The Sizewell C Project

5.1 Consultation Report Addendum Annex A: Copies of all consultation responses - Part 2 of 2

Revision: 1.0
Applicable Regulation: Regulation 5(2)(q)
PINS Reference Number: EN010012

January 2021

Figure 1. Blythburgh traffic issues and proposed mitigation

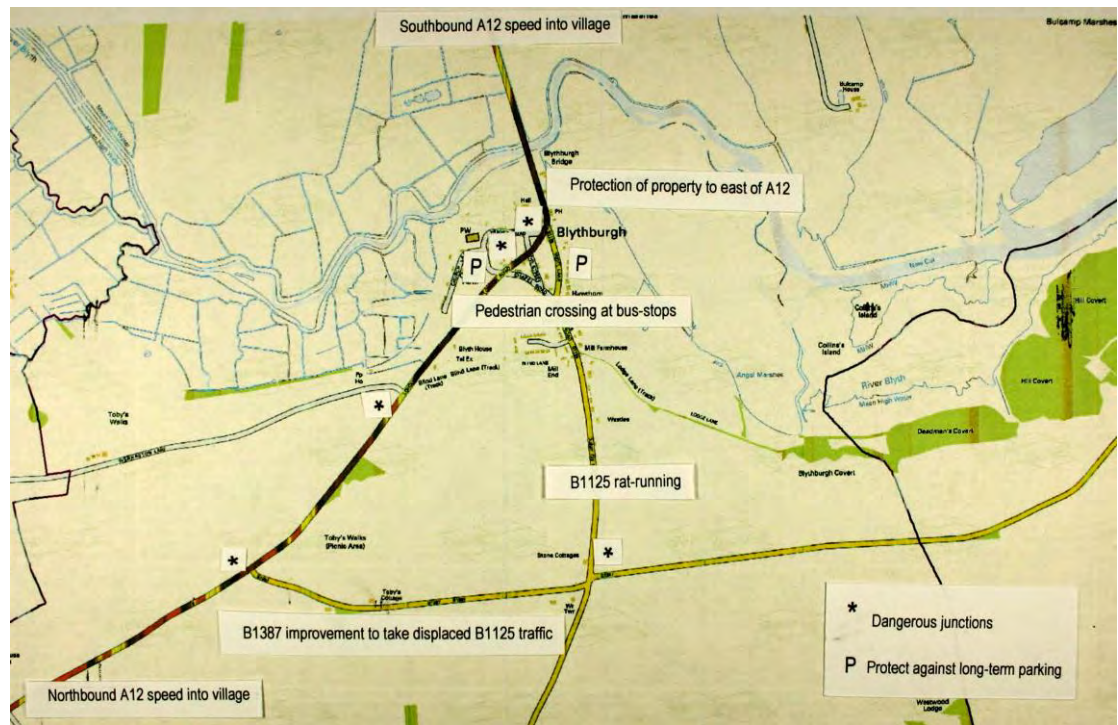
See 1.12 above for a list of topics for discussion. Fig.1 below illustrates the traffic issues and proposed mitigation.

Figure - 1a.
Ipswich (West Bank Terminal)

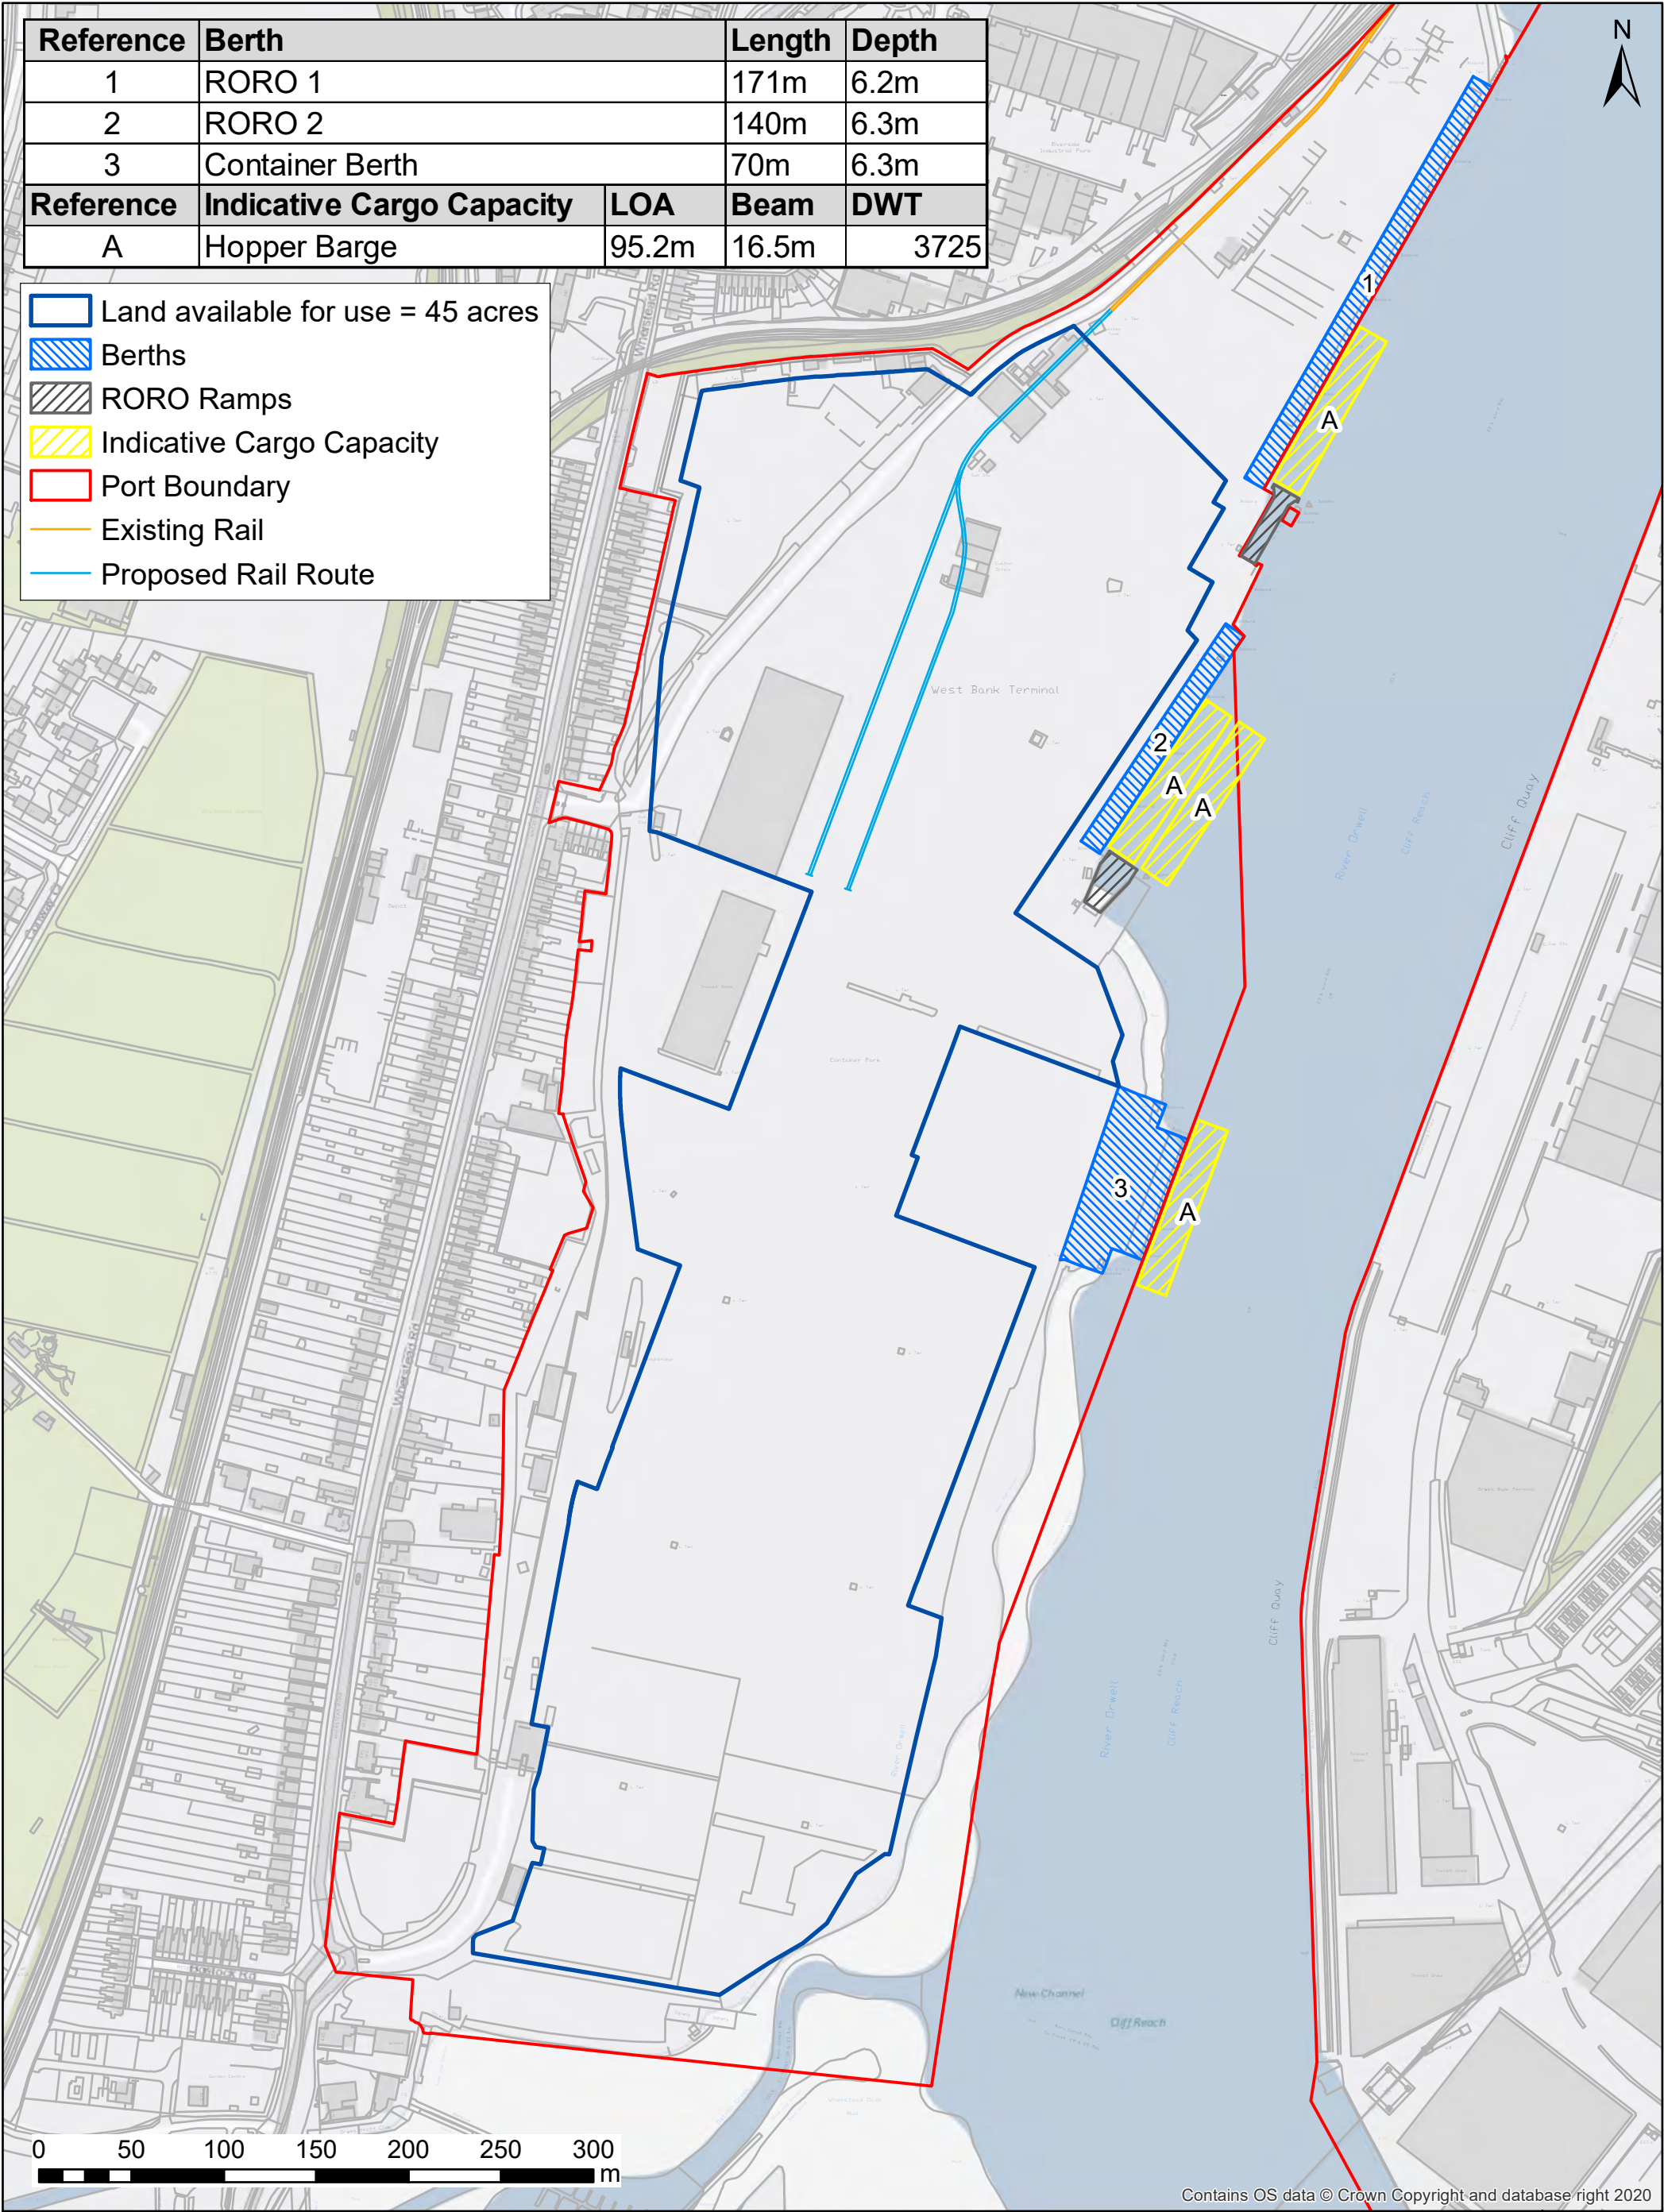
- The ability of both ports to provide adequate land to develop VQ's is clear ahead of the proposed 2025 start date. This would help ensure a steady flow of material to the development sites during 2025-2027. (See Fig 1a, ref Land available for use and Fig 2a, ref X & Y)
- We would welcome further engagement on the inbound logistics for 'fill and cementitious material', Cementitious material is suitable for inbound train movements whilst fill material is more easily capable of being moved by sea, rather than road or rail., potentially helping to provide enough outbound rail capacity from the VQ to the SZC development site.

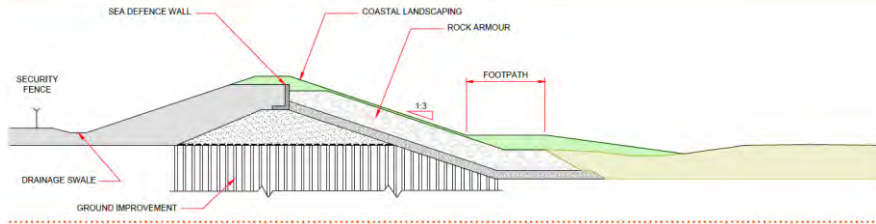
<p>the rock structure. The hydraulic performance of rock revetments depends on the voids being open to aid the attenuation of energy within them. Filling them up would only diminish the eventually needed hydraulic properties, potentially aggravating overtopping wave absorption and stability of outer layer rocks, whilst increasing unwanted wave reflection.</p>	<p>introducing soil to the rock revetment are taken into account and designed for.</p>	
98	4.8.7	<p>Figure 4.18 Temporary sea defence</p> 	<p>The figure does not provide any dimensions, levels, or positional reference. Without quantitative detail the figure is of limited usefulness.</p> <p>A query also on the impact of the vertical wall when exposed to waves. The wall is expected to be exposed to wave action, in fact the design provides for a heightening of the wall to cater for future conditions.</p>	<p>Request for Further Information: Please provide a version of this drawing complete with levels and dimensions. Please advise the impacts of such a wall on the beach to seawards, and how this would be managed.</p>

<p>4.8.7. An alternative sheet-pile sea defence is proposed for the construction phase of the project, as illustrated in Figure 4.18. This alternative design has similar performance features to the construction phase HCDF within the Application, but significantly increases the amount of space within the construction site for marine shafts and tunnelling and simplifies the construction process, as explained in more detail in this section. The temporary sea defence would have a maximum height of approximately +7.3mAOD for the majority of its length and would then raise further (to approximately 10.5 AOD) to meet the SZB sea defence.</p>	<p>Being a vertical wall it would be reflective to waves. Subject to it being high enough, it has potential to be an effective barrier to sea incursion. However, this means that wave energy that would otherwise be expended at the shore will be maintained on the seaward side of the wall where it would likely cause localized erosion and suspension of sediments, leading potentially to accelerated sediment loss.</p>

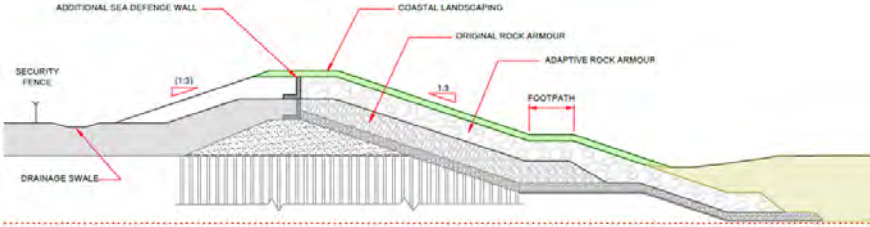
98	Fig. 4.19	<p>Figure 4.19 Permanent sea defence, operational phase</p> 	<p>The figure does not provide any dimensions, levels, or positional reference. Without quantitative detail the figure is of limited usefulness.</p>	<p>Request for Further Information: please reissue this and similar drawings complete with dimensions, levels, and positional references, e.g. in relation to MHWS line, and the SCDF.</p>

98	4.8.10	<p>4.8.10. The design of the buried toe of the sea defence has been further progressed in response to stakeholder feedback and will now be set at approximately 0mAOD at the outset of the operational phase.</p>	<p>Without further detail on the Figure it is supposed that the 0mAOD refers to the underside of the toe. It is usual for the toe to extend below the deepest level that natural erosion can reach. Even allowing for future adaption of the defense structure, this interim level would appear to be rather shallow.</p>	<p>Confirmation required: has the security of the toe against beach losses and scour been fully investigated and designed for? What is the designed-for lowest beach level that's taken into account?</p>	
99	Fig. 4.20	<p>Figure 4.20 Permanent sea defence, adaptive design</p> 	<p>The figure does not provide any dimensions, levels, or positional reference. Without quantitative detail the figure is of limited usefulness.</p> <p>This figure more clearly identifies the coastal landscaping. There must be suitable geotextile or suitable membrane the isolate the landscaping soil from the voided rock mound.</p>	<p>Request for Further Information: please reissue this and similar drawings complete with dimensions, levels, and positional references, e.g. in relation to MHWS line, and the SCDF.</p>

<p>Please provide details of how the landscaping material is to be isolated from the voided rocks.</p> <p>Also please advise as per the comment on p97 4.8.4.</p>	
100	Table 4.6	<p>Coastal Geomorphology and Hydrodynamics</p> <p>There would be no change to the present-day baseline environment for coastal geomorphology and hydrodynamics (because the coastal defence is set back from the coast).</p>	<p>The installation is expected to be in place beyond the present day, i.e. for up to 190 years (?), during which time the HCDF will interact directly with the coastal processes. As a result, the HCDF has potential to have negative impacts on the coastal processes. The change to the length of the structure seawards means that any such negative impacts will happen sooner.</p>	<p>Clarification required: the Table 4.6 statement is unclear and needs to be expanded to reference the future evolution of the shore with respect to the changed length of the structure.</p>
